Access Compliance Report Public Rights-of-Way (Curb Ramps)

Main Street: UNIVERSITY_AVE		Cross Street: WOODBRIAR		Location:	SE
ADA ID: RPRK220223152657	Ramp Type:Type 1 - Perpendicular	Initial Pass/Fail: Pass	Overall Compliance: No	Severity Score:	15
Codes/Mitigation Info/Possible Solution			Field Measurements/Component Compliance

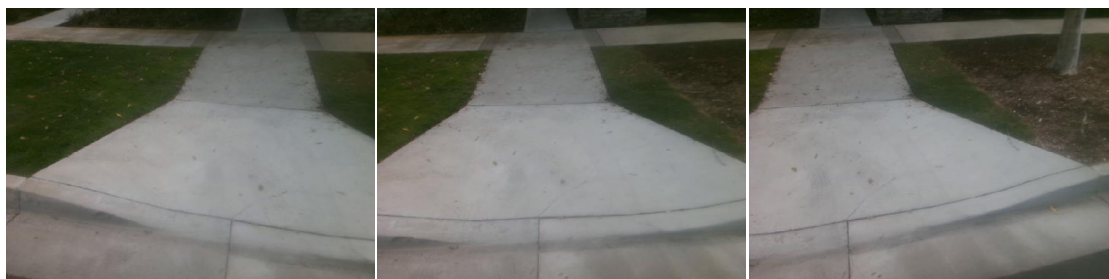
Compliance	Description	Data	Compliance	Description	Data
N/A	Ramp Length (in)	162	N/A	Flare Type LT	
Yes	Ramp Width (in)	48			Sloped
Yes	Ramp Run Slope (%)	7.2	N/A	Flare Slope LT (%)	N/A
Yes	Ramp Cross Slope (%)	1.4	N/A	Flare Traversable LT	No
N/A	Landing Present	Yes	N/A	Flare Type RT	
N/A	Landing Length (in)	59			Sloped
Yes	Landing Width (in)	70	N/A	Flare Slope RT (%)	N/A
No	Landing Run Slope (%)	2.1	N/A	Flare Traversable RT	No
Yes	Landing Cross Slope (%)	2.1	No	DWS Provided	No
N/A	Landing Movement Obstructed?	No	N/A	DWS Contrast	N/A
	Landing Movement Type	N/A	N/A	DWS Length (in)	N/A
N/A	Landing Shared	No	N/A	DWS Full Width	N/A
N/A	Clear Space	N/A	N/A	DWS Offset Left (in)	N/A
N/A	Clear Space To Crosswalk (in)	N/A	N/A	DWS Offset Right (in)	N/A
N/A	Marked Crosswalk 1	No	N/A	Marked Crosswalk 2	N/A
	Crossing 1 Direction	W		Crossing 2 Direction	N/A
	Marked Crosswalk 1 Width (in)	N/A		Marked Crosswalk 2 Width (in)	N/A

N/A	Ramp Inside Crosswalk 1	N/A	Yes	Ramp Inside Crosswalk 2	N/A
	Crossing 1 Slope (%)	1.5		Crossing 2 Slope (%)	N/A
	Crossing 1 Cross Slope (%)	2.6		Crossing 2 Cross Slope (%)	N/A
Yes	Gutter Ponding	No	Yes	Curb Slope	2.6
Yes	Gutter Lip Height (in)	0		Road Run Slope (%)	N/A
No	Gutter Run Slope (%)	11.6		Road Cross Slope (%)	N/A
Yes	Gutter Cross Slope (%)	1			
Yes	Overall Surface Condition: Acceptable		Yes	Perp Joint Present	Yes
	Cross Gutter Present?	No		Spandrel Present?	No
	Replace Cross Gutter?	N/A		Replace Spandrel?	N/A

Remove & Replace Entire Ramp. Remove & Replace Gutter.
